North Lily Mining Company

Extension Project Phases I through III

We received revised plans and specifications for the subject project on March 6, 1991. We have the following comments:

E - E' LEACH PAD'DETECTION SUMP' PHASE I

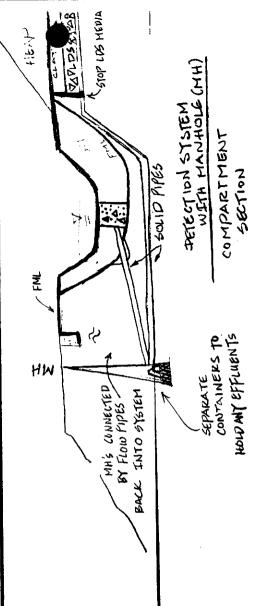
- 2. Drawing Sheet 6, Section E-E', and similar drawings will need revision. Ditches and uncovered liner areas for leachate flow need subsurface sumps compartmented transversely to the flow direction with confining clay dams or other means, to help define any leakage to zones of these areas. These areas should be lined beneath, with a flexible membrane liner (FML). See the attached drawing. This configuration will allow early detection of leakage isolated to these areas. Continuous solid monitoring pipelines connected to the perforated collector pipes will isolate any leakage flow to specific areas of the pads for each such pipeline.

MONITURING COMPARTMENT FOR LEAKAGE

SUGGESTIVE DETAILS
